SUBJECT: FORT CALHOUN STATION, UNIT NO. 1 - ISSUANCE OF AMENDMENT
(TAC NO. MB7496)

SAFETY EVALUATION BY THE OFFICE OF NUCLEAR REACTOR REGULATION

RELATED TO AMENDMENT NO.222 TO RENEWED FACILITY

FORT CALHOUN STATION, UNIT NO. 1

Figure 1 Staff scoping study - Effect of Tagami to Uchida transition rate on LOCA pressure calculation

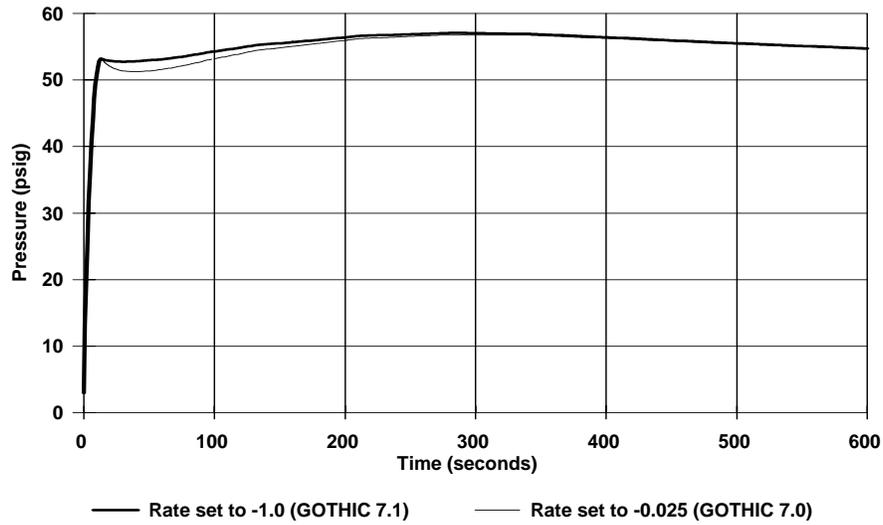
An exponential-based model is used to transition from the maximum heat transfer rate obtained from the Tagami correlation to the heat transfer rate obtained from the Uchida correlation. In GOTHIC 7.0, the exponential rate was set to -0.025 per unit time. In CONTRANS, the exponential rate was set to -1.0 per unit time, to maximize the calculated pressure, resulting in a more rapid reduction in the heat transfer rate. As a result, there is a small difference in the pressure calculation in the GOTHIC 7.0 benchmark study when compared to the CONTRANS AOR following the first pressure peak at about 14 seconds. The calculated pressure following the first peak showed a larger decrease as a result of the higher heat transfer rates obtained with the GOTHIC 7.0 transition model. The staff performed a scoping study with GOTHIC 7.1 to evaluate the effect of the exponential rate on the calculated peak pressure (Version 7.1 allows the user to control the transition model exponential rate). The results are provided in Figure 1 attached to this safety evaluation. This study confirmed the licensee's assessment of the exponential rate and indicated that the peak pressure would be about 0.25 psi higher with the more conservative CONTRANS exponential rate. The GOTHIC 7.0 exponential rate was selected to be consistent with ANSI/ANS-56.4-1983⁹, and is considered to be a conservative value. The staff concludes that the transition model used in GOTHIC 7.0 is acceptable for licensing analyses. This transition model was also previously determined to be acceptable by the staff as part of the Kewaunee review (ADAMS Accession No. ML012490176).

Figure 2 Staff scoping study - Effect of SIT nitrogen gas on LOCA pressure calculation (GOTHIC 7.0)

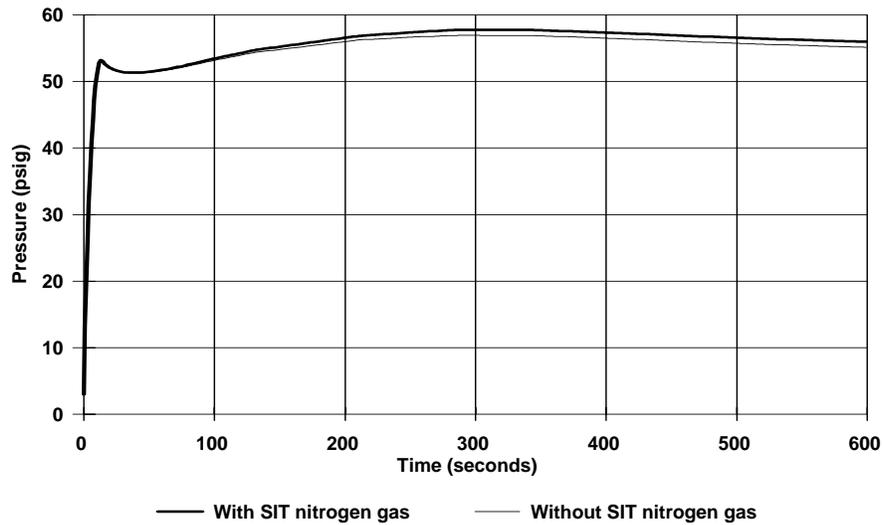
scoping study with GOTHIC 7.0 to assess the effect of the SIT nitrogen cover gas. The results, shown in Figure 2 attached to this safety evaluation, indicated that SIT nitrogen cover gas increased the calculated containment pressure by about 0.85 psi. The change in the calculated containment temperature was negligible.

Figure 3 Staff scoping study - Effect of radiation heat transfer on MSLB calculated pressure (GOTHIC 7.0)

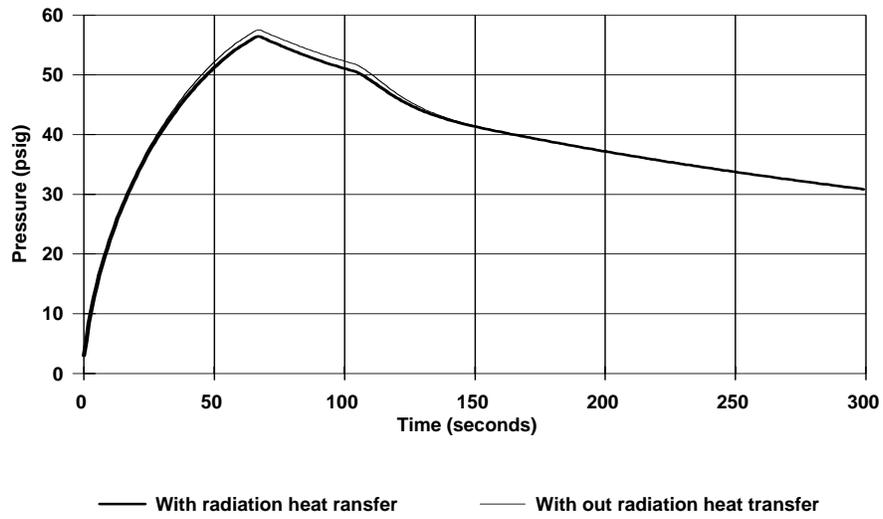
The staff performed a GOTHIC 7.0 scoping study to evaluate the effects of containment atmosphere (vapor) to containment heat structure radiation heat transfer. The pressure response is shown in Figure 3 attached to this safety evaluation and the temperature response is shown in Figure 4 attached to this safety evaluation. The peak pressure is about 1.1 psi higher without radiation, but still within the design base. The peak temperature is about 14°F higher without radiation, but still below the current AOR value.
